Contract Administration G701 Change Order
Leyendecker Construction Proposed Change Order
City of Laredo - Fire Department Application # 20-6596
Fire Sprinkler System Blueprints

PROJECT (Name and address):
[UISD – Cuatro Vientos Middle School](#)
[Laredo, Texas](#)

CHANGE ORDER NUMBER: [02](#)

**UISD Cuatro Vientos Middle School
Proposed Change Order**

System 2 Fire Protection 2nd Floor

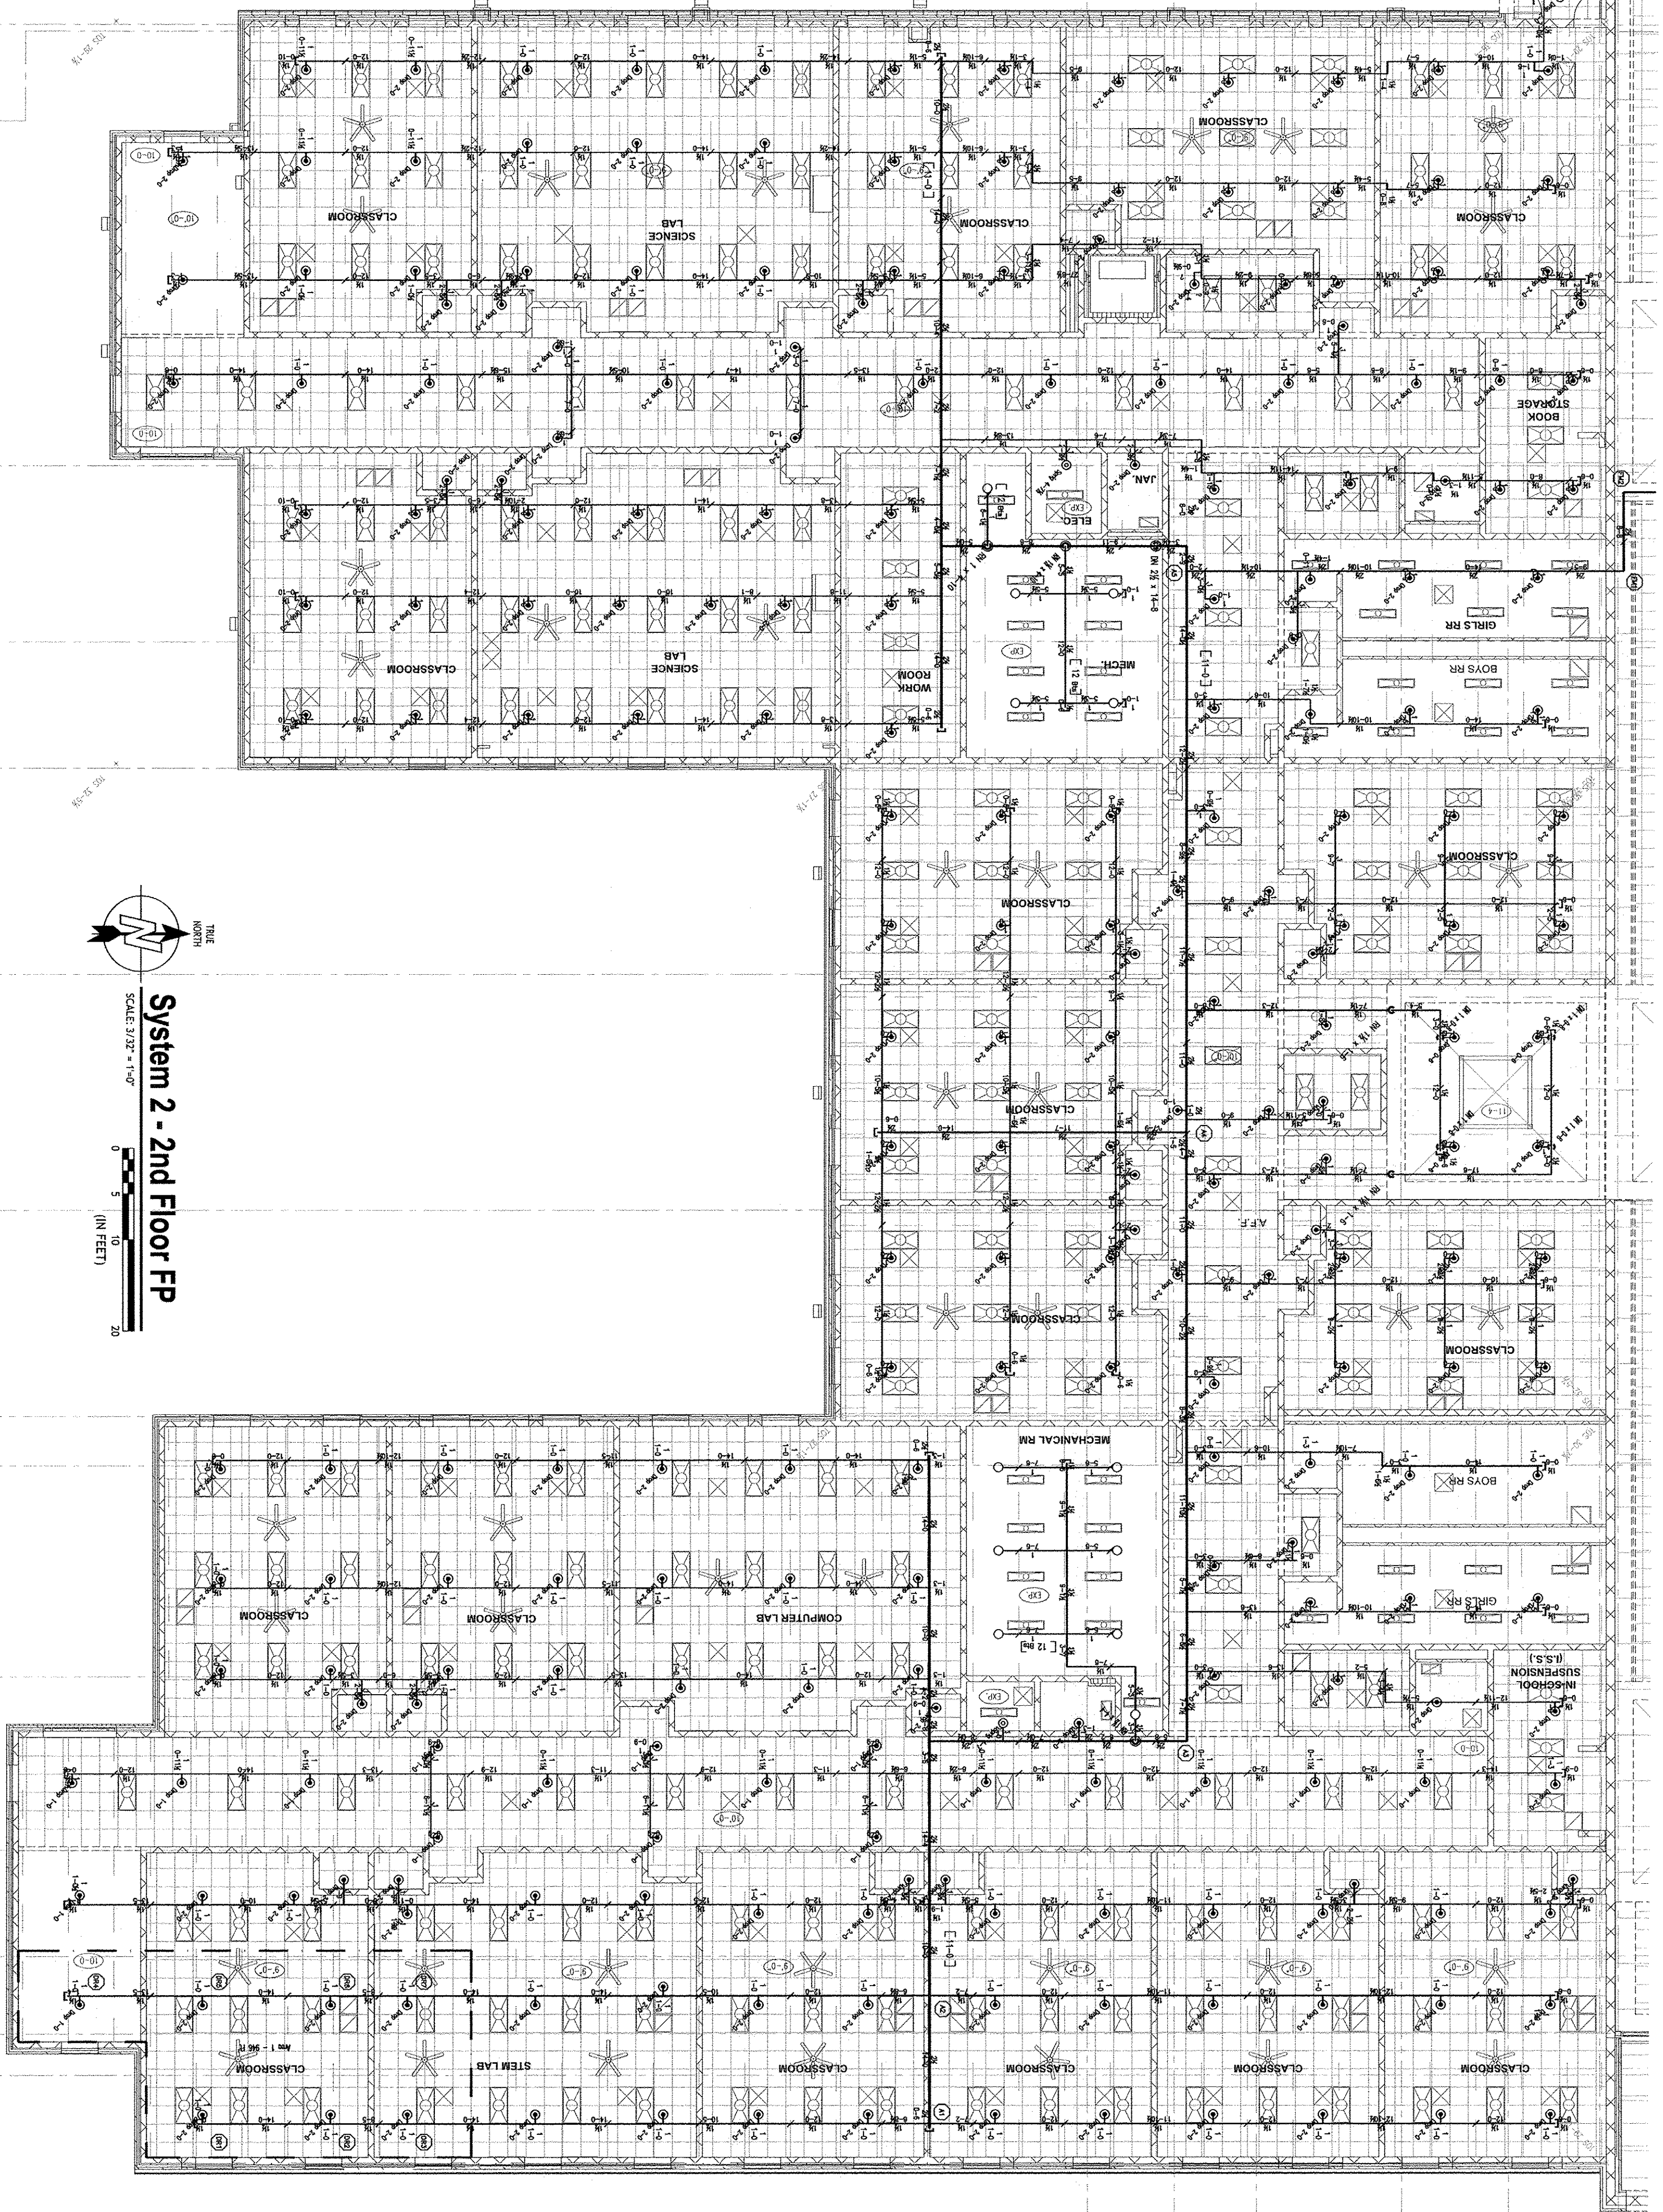
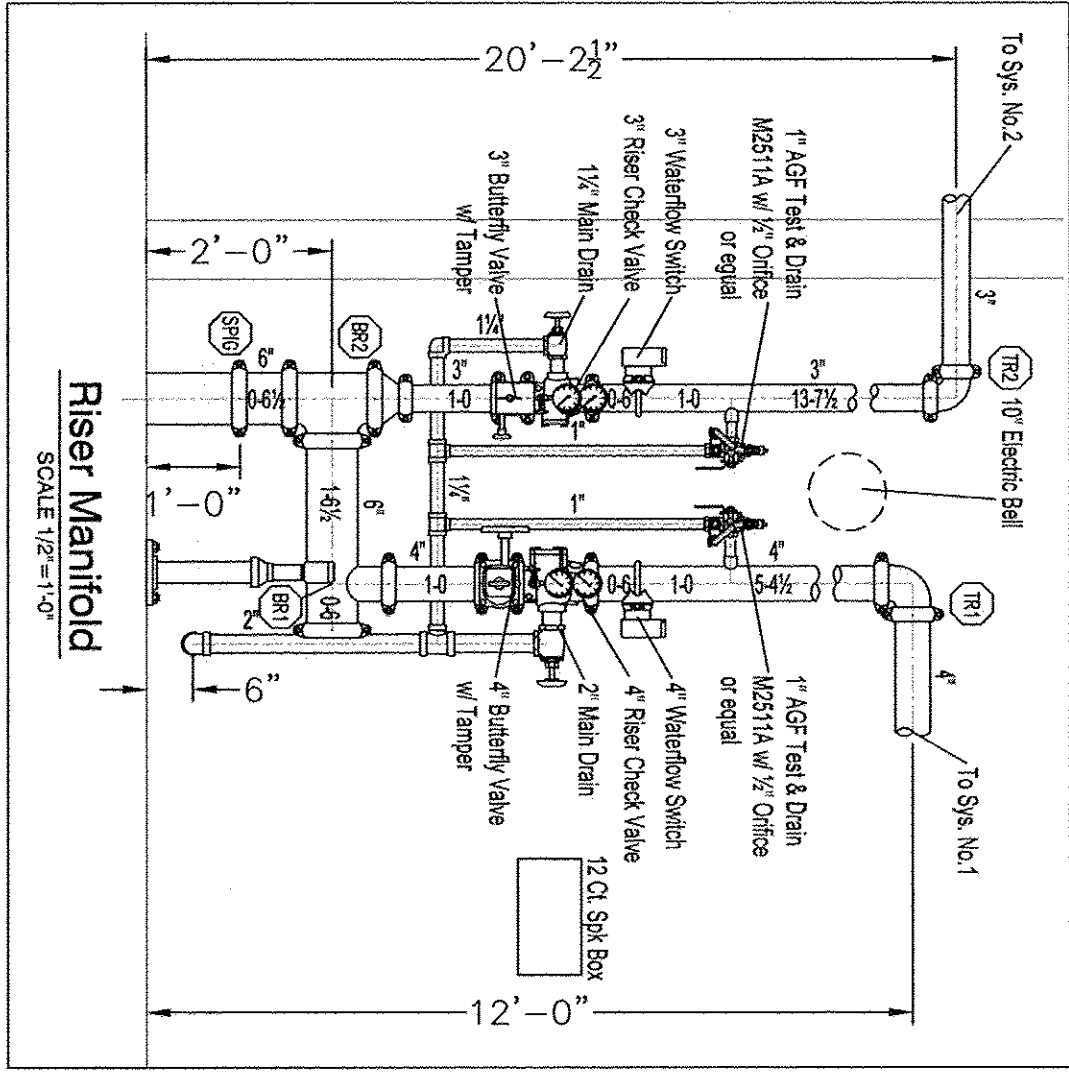
The fire sprinkler system blueprints for the overhead sprinkler system for **LISD Cuatro Vientos @ 4301 Vientos**, submitted to our office, has been reviewed: **111,000 SQFT; 883 Heads**

Plans approved as submitted. FDC sign height will be subject to field inspection. FDC and piping shall be hydrostatically tested.
